C2 12/4/19.
BHK
(Ground floor)

C2
2BHK
(Ground floor)

(C2) GR. FIR ELECTRICAL DWG.

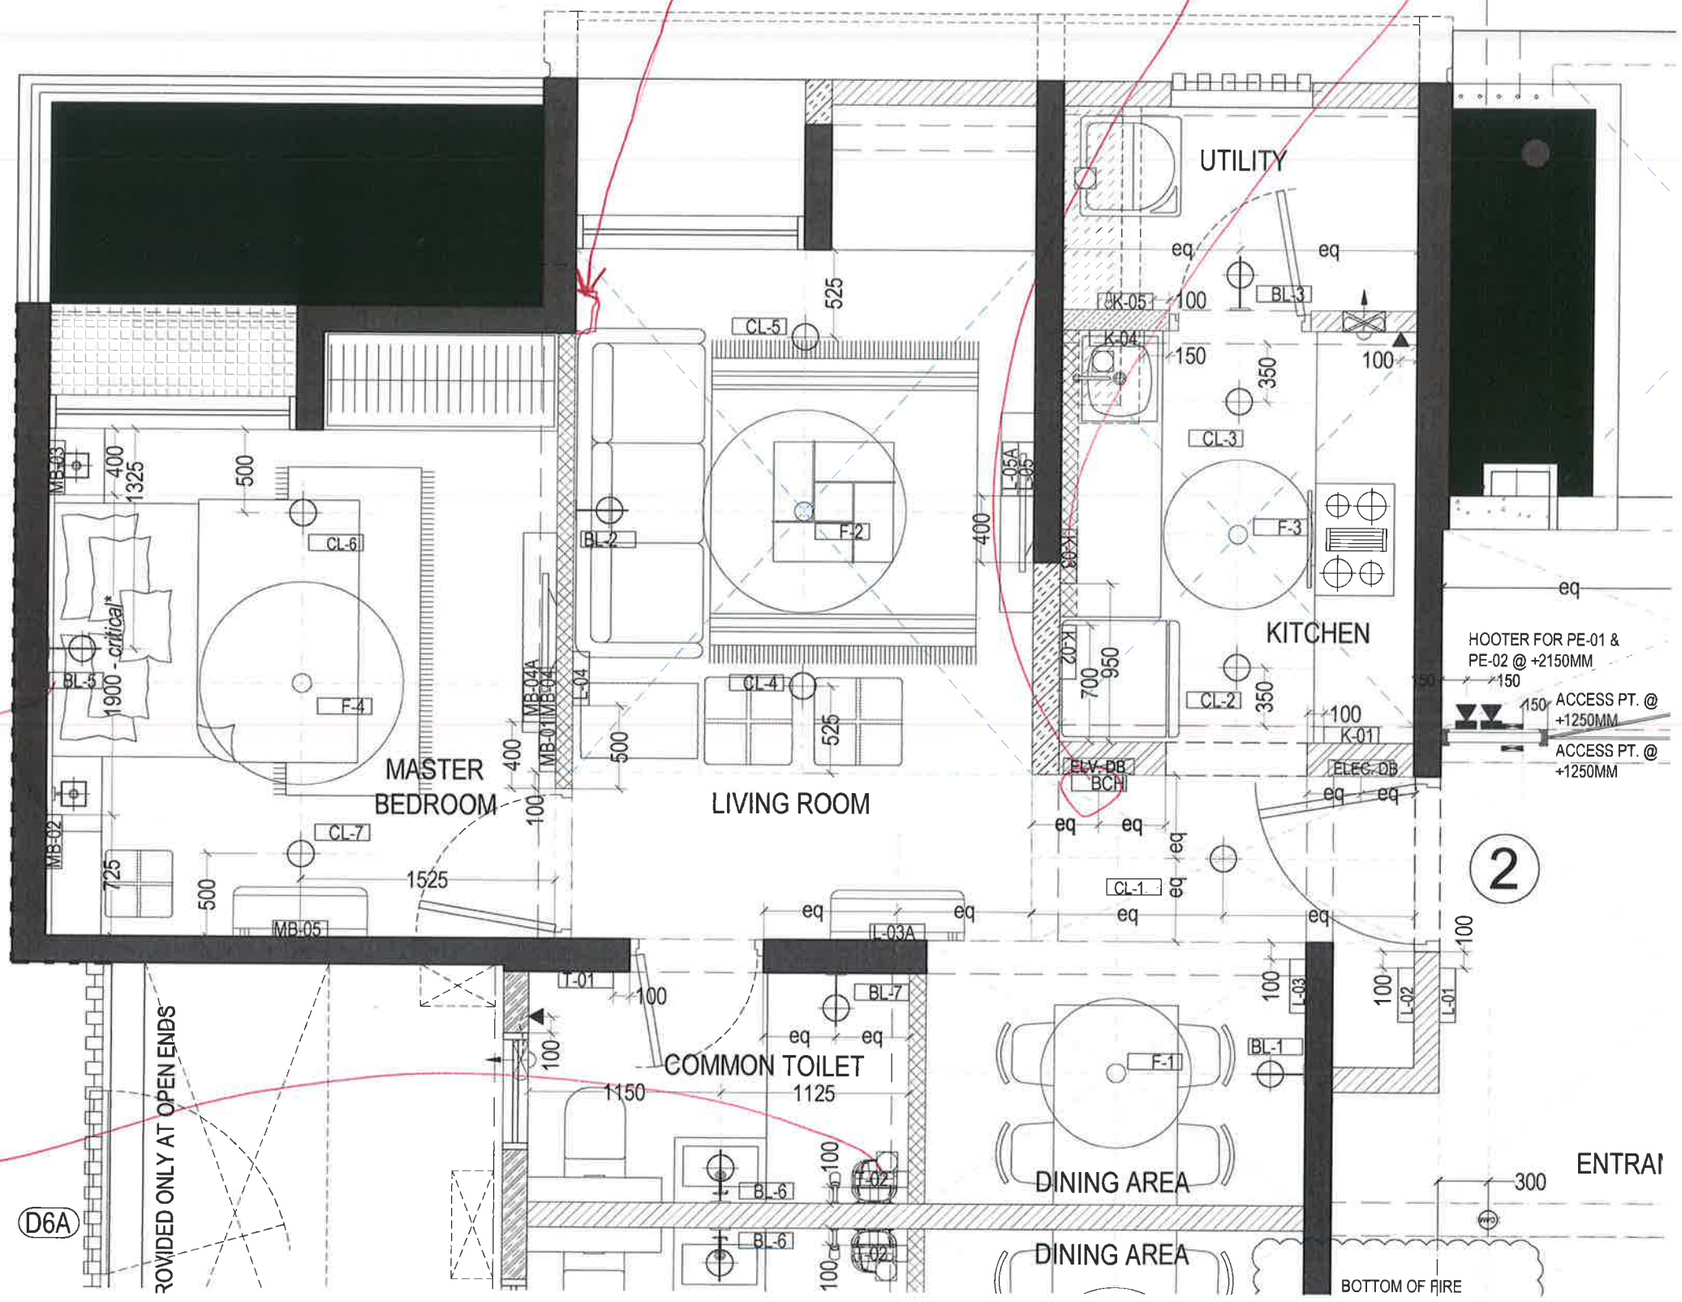
Remove one switch socket + CL5 from LOH + put it here

BCH will clash with DB. Relocate

SHIFT ON Blockwork wall.

BL-05 to be on MB2 SB. Missing in Schedule.

T02 - Not clear on which wall.

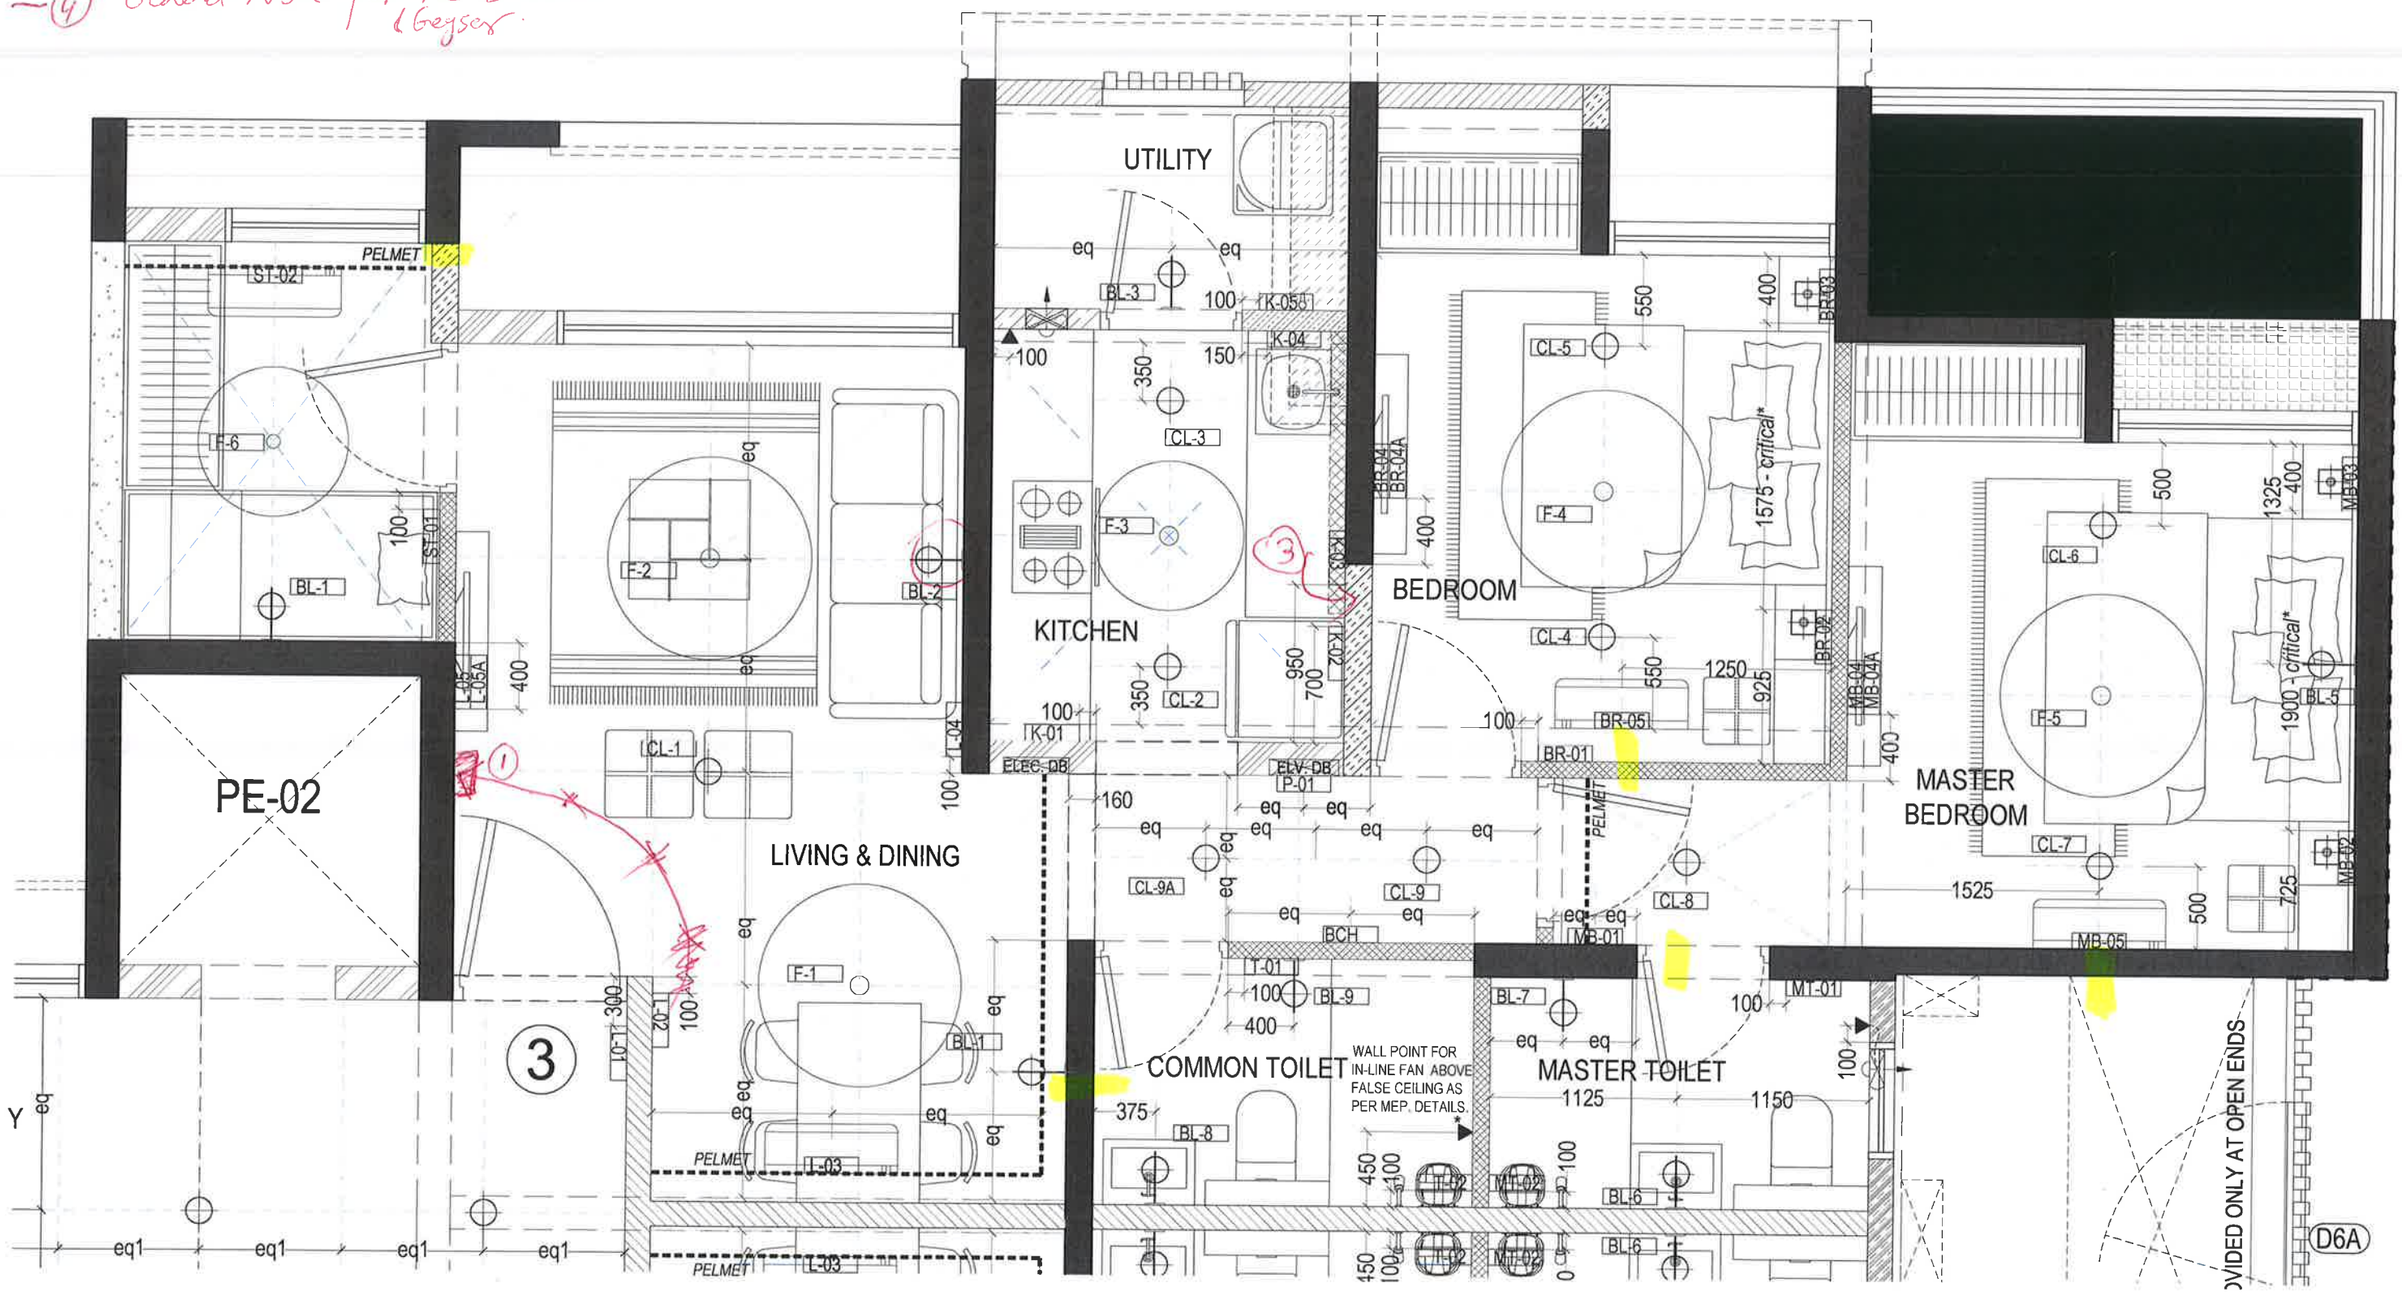
(1) ~~LIGHT~~ LIGHT POINT TO ~~SHEET~~ BE GIVEN (CL1)

(2) CHECK HT OF THE BRACKET LIGHTS. IT WILL CLASH WITH AC.

(3) CHECK IF K03 can be shifted on Blockwork wall.

(4) General Note for AC switch with indicator & Geyser.

(1) Please discuss with Ebrahim on the location of Access Release Button. Currently we are facing issues of customers operating the internal release button from outside to open the doors.

(2) Also Discuss Lift / Heater location

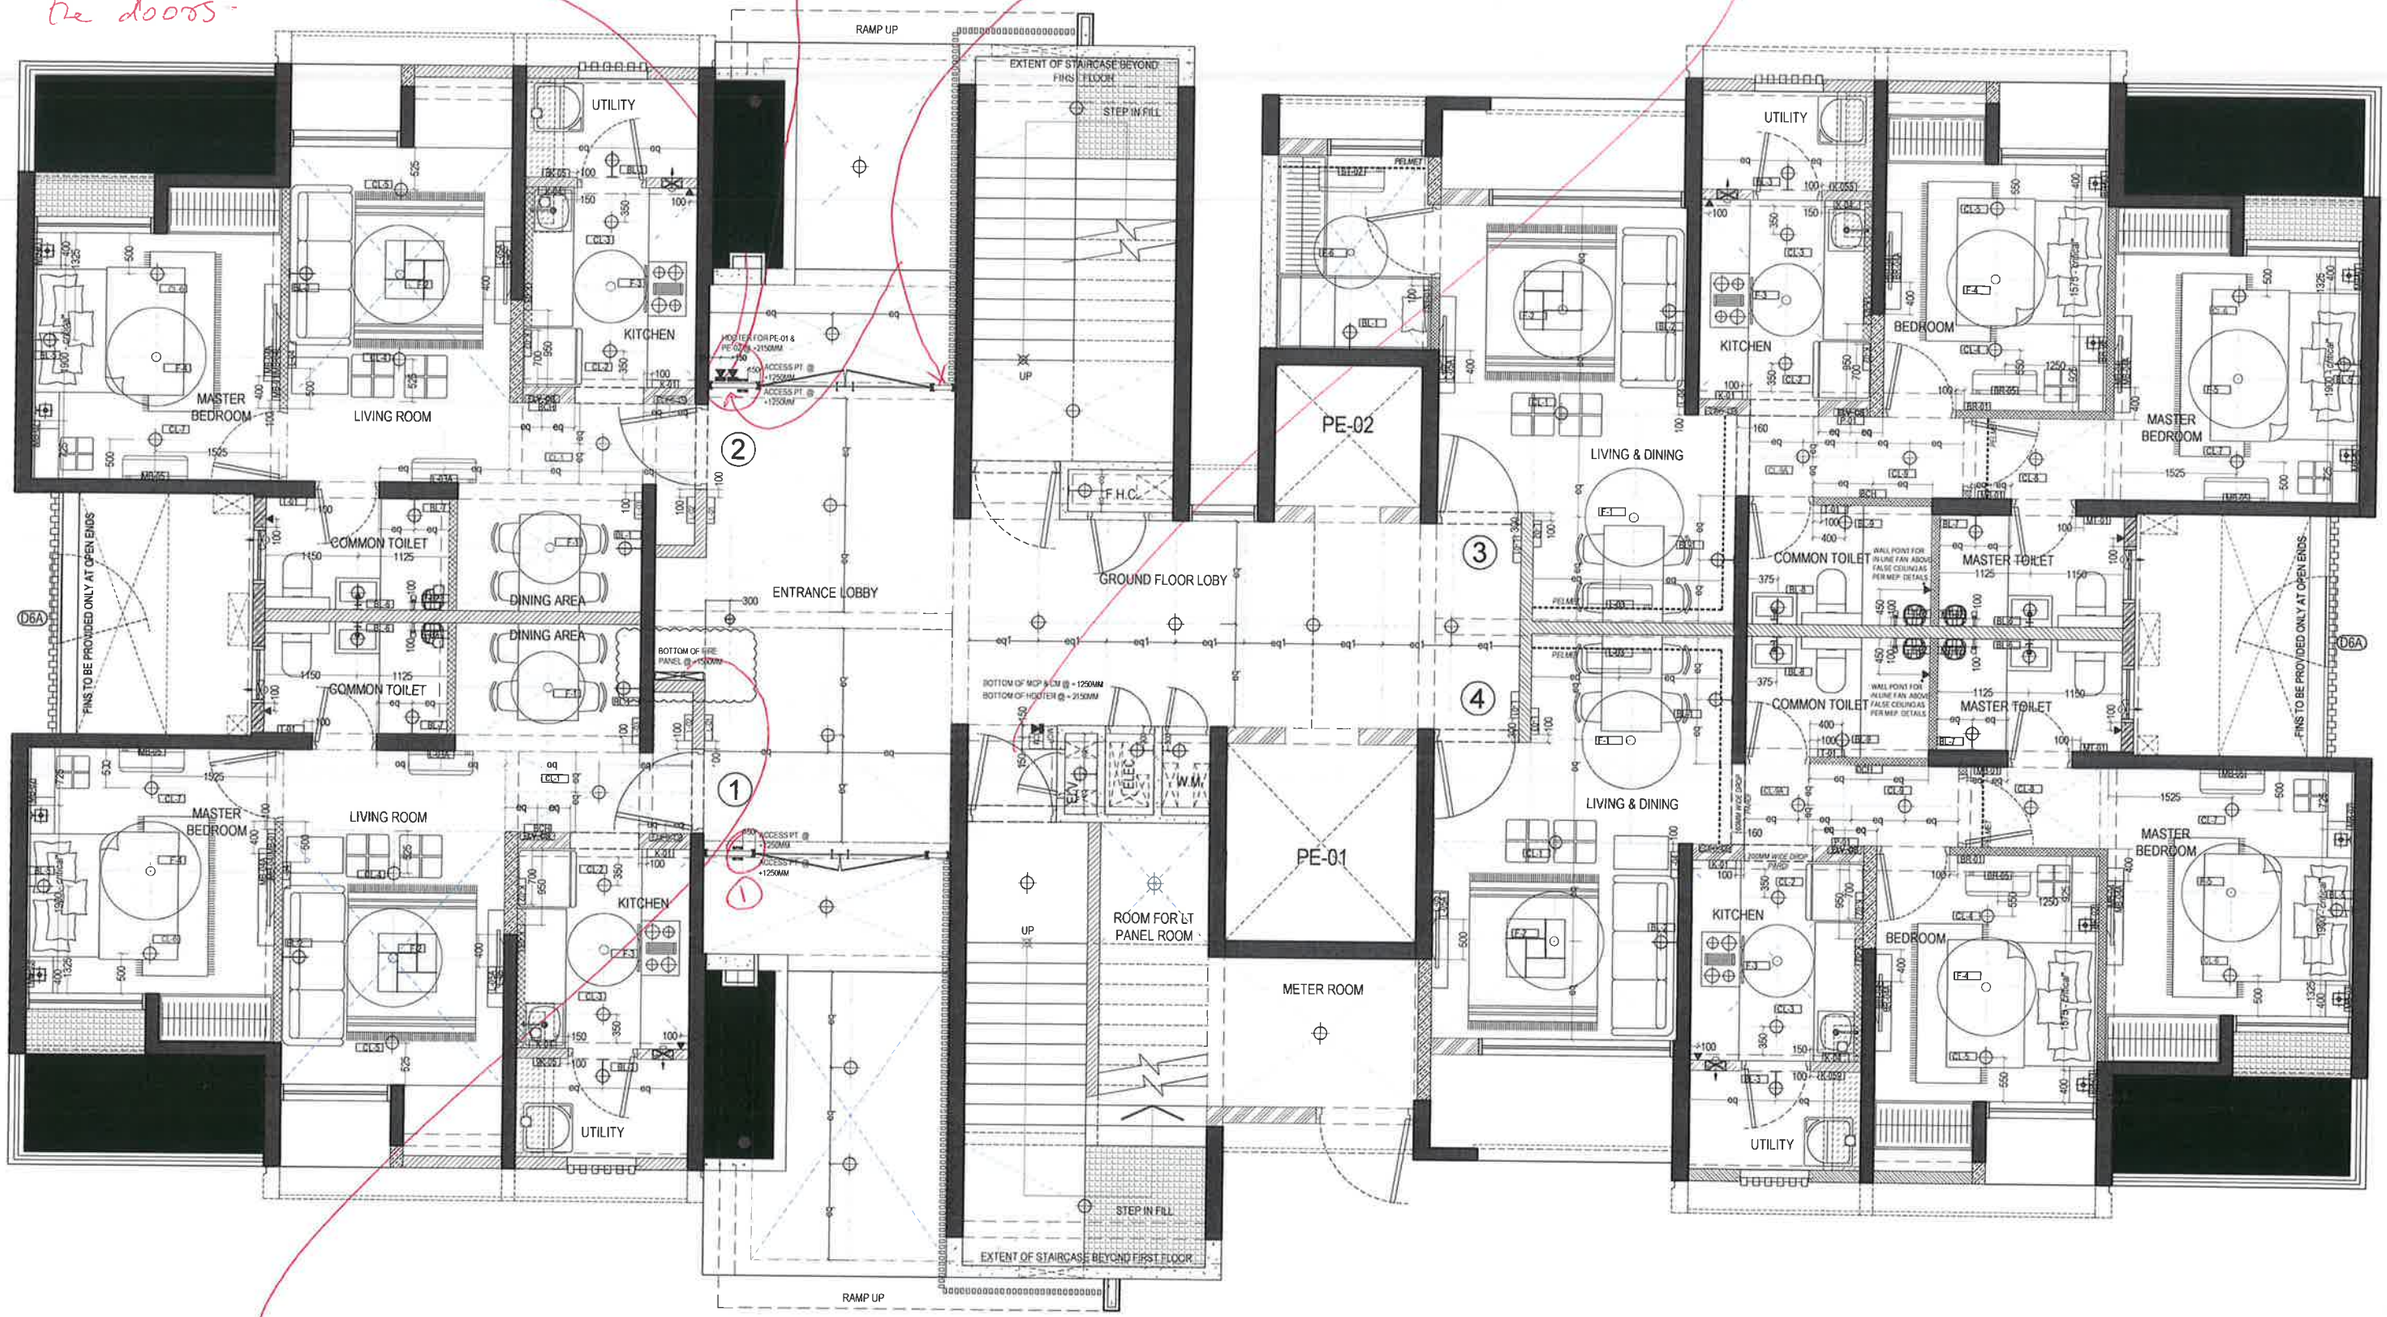
(3) Discuss with ME if any jali/louvers reqd for lobby ventilation as the lobby is not airconditioned.

(4) Add control module to Legend.

(5) Check Fire Panel location with ME. Also check if size fits in the condition.

(6) CHECK ALL THE SLEEVES REQD FOR THE A.C / Water meter routing & convey to SBC (We can discuss together) But please mail.
